SPECIFICATION, SPECIAL PROVISIONS AND DRAWINGS
REVISION TO STANDARD SPECIFICATIONS AND DRAWINGS

PROPOSAL TO STANDARDS COMMITTEE

PROBLEM(S) ENCOUNTERED: Bridge Standards 707 thru 731 need to be revised and updated for content and presentation.

AGENDA ITEM 03

EXISTING 707-BPBB-01 BRIDGE PRESTRESSED BOX BEAM ADJACENT BOX BEAM (PROPOSE TO DELETE)

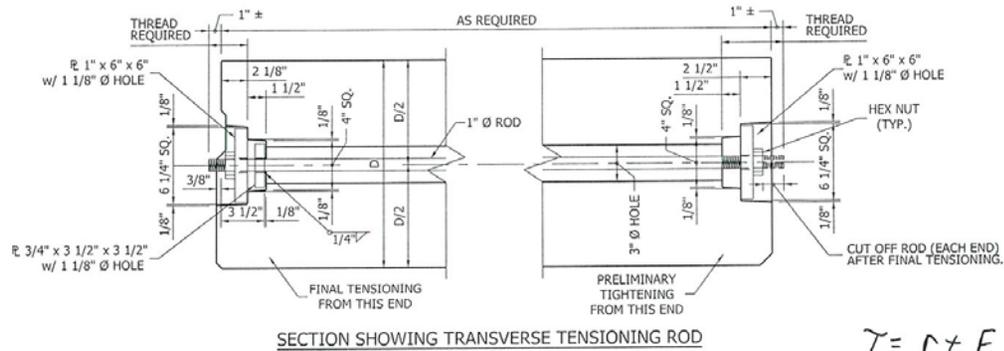
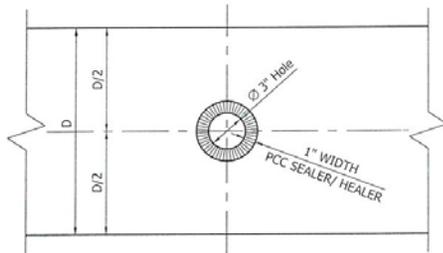
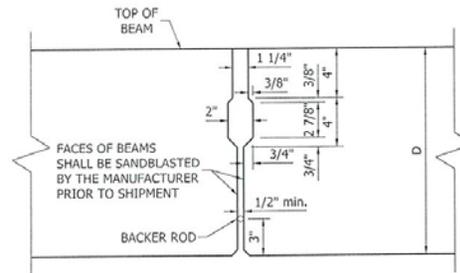
APPLICABLE DESIGN MANUAL SECTION: 406-12A Figure showing transverse tensioning rods will be deleted.

EXISTING 707-BPBF-02 FABRICATION TOLERANCES PRESTRESSED I BEAM (WITH MARKUPS)

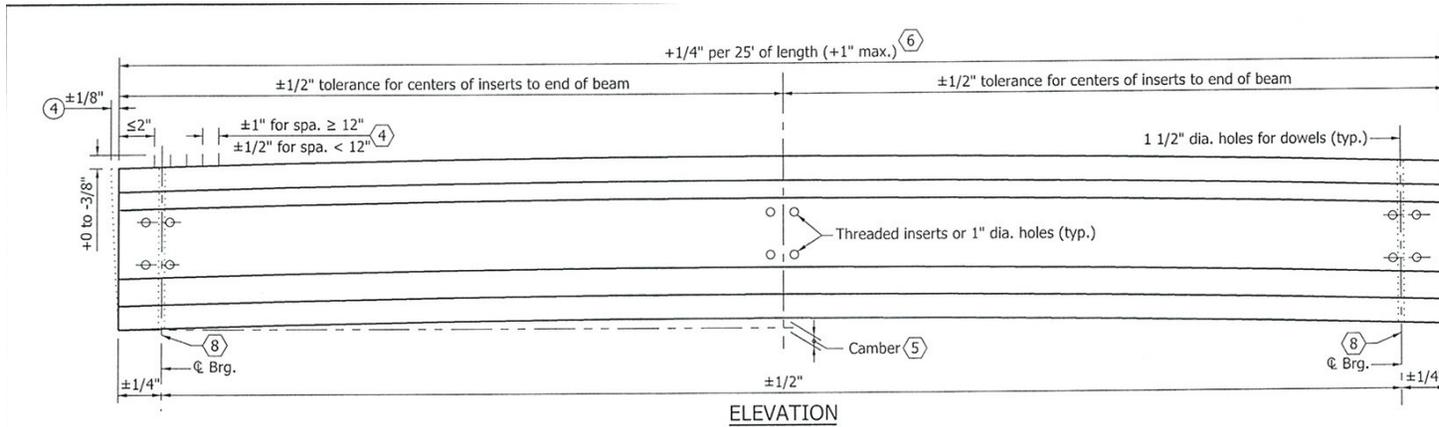
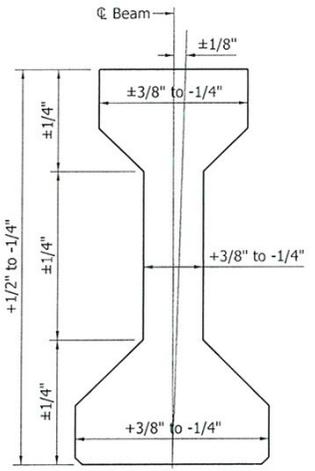
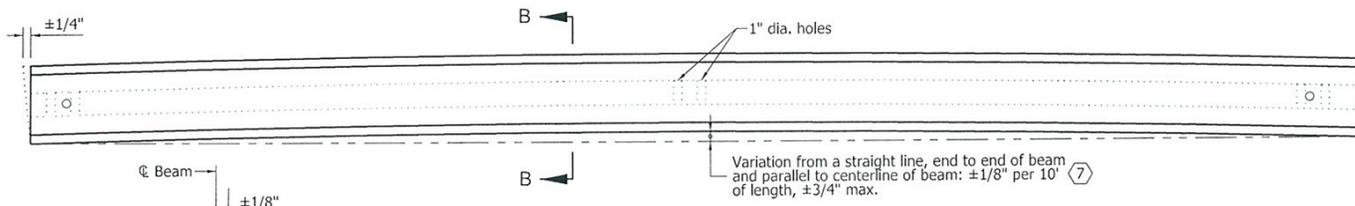
Tolerance added for holes

EXISTING 707-BREB-01 STEEL STRUCTURES (PROPOSE TO DELETE)

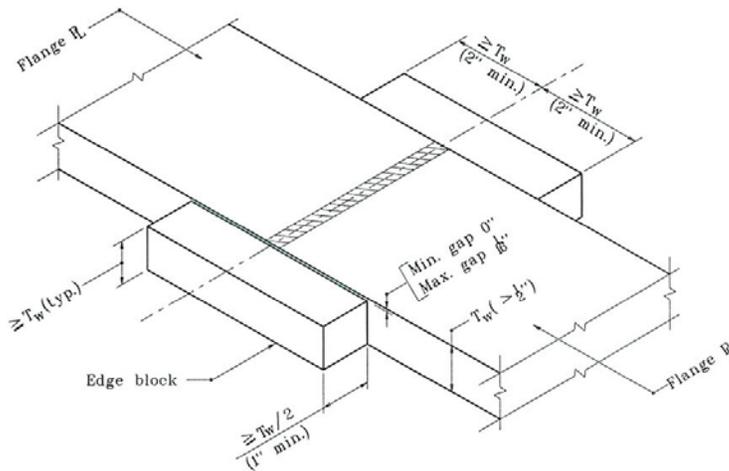
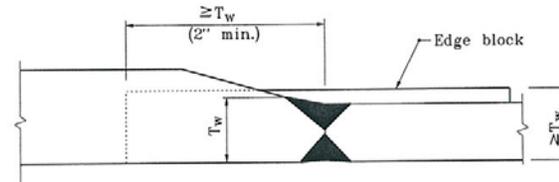
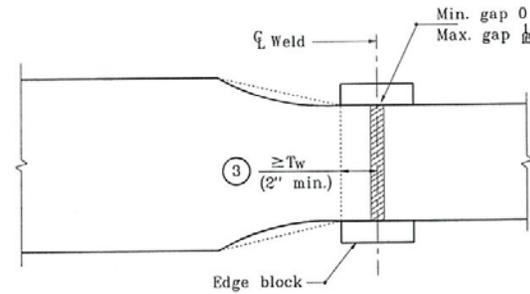
Mike McCool IDM fig 907-1C

6.2 AASHTO/AWS D1.5:2010

EXISTING 711-BSTS-02 EXPANSION STEEL SHOE DETAILS (PROPOSE TO DELETE)

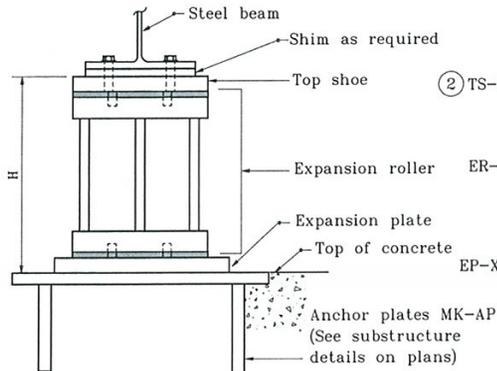
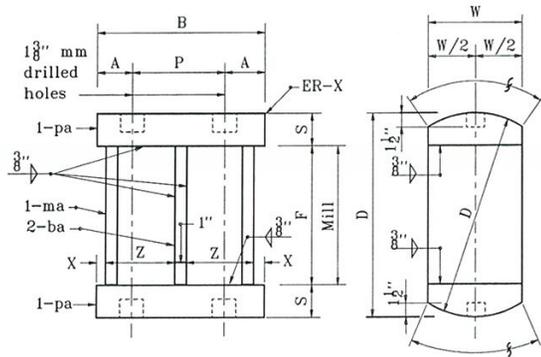
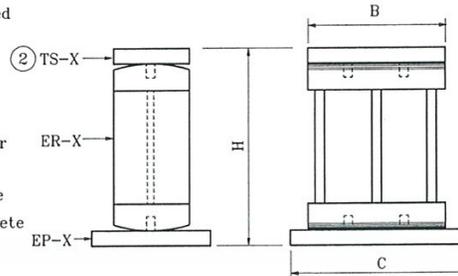
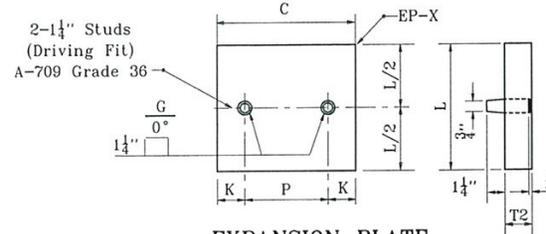
AASHTO 19.7
 Such details should be avoided.
 High risk of loss of bearing

EXISTING 724-BJTS-02 TYPE BS EXPANSION JOINT (PROPOSE TO DELETE)

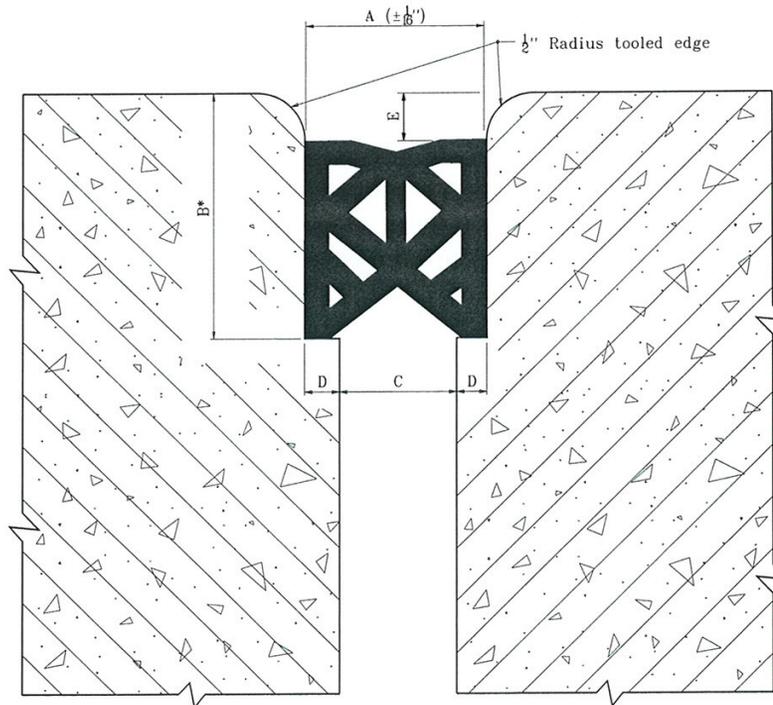
Standard was to be deleted - has not been approved for use for several years.

EXISTING 724-BJTS-04 BEAM END SLAB NOTCH TYPICAL DETAILS (PROPOSE TO DELETE)

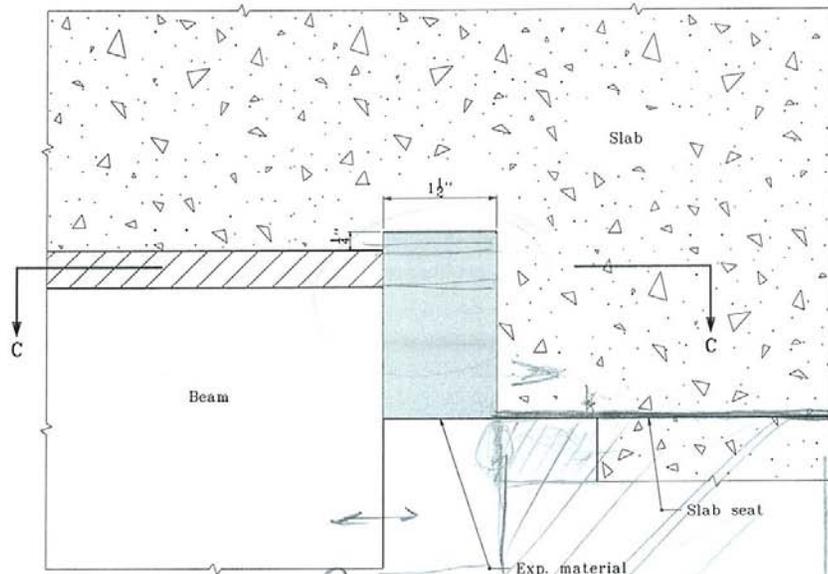
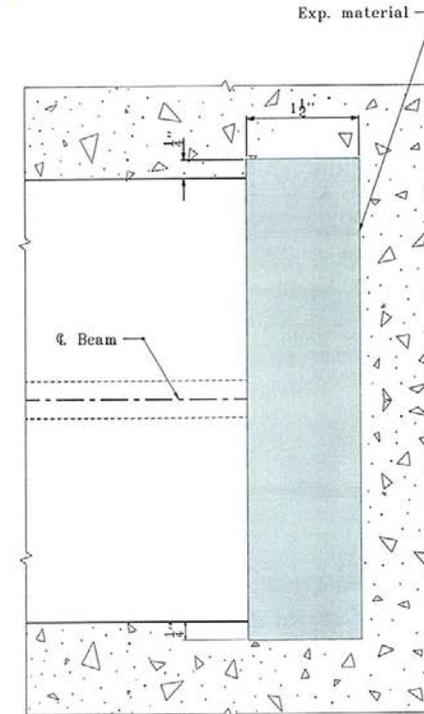
Non-composite - jointed bridge decks

EXISTING 724-BJTS-06 OPTIONAL RAILING VERTICAL REINFORCEMENT SPLICE (PROPOSE TO DELETE)

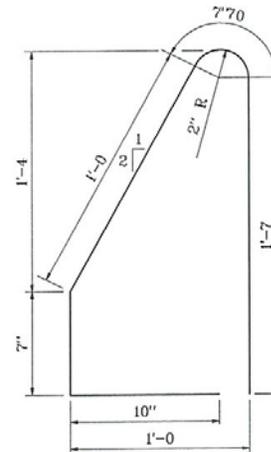
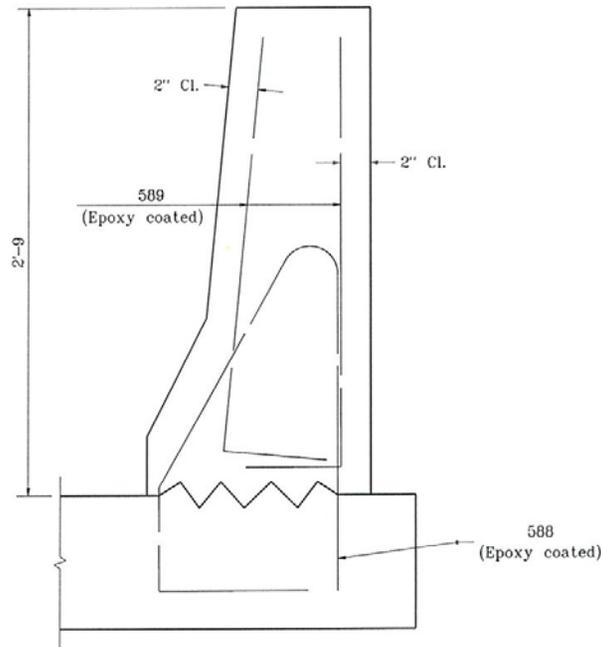
This alternate can not be allowed. This reinforcement configuration has not been crash tested.
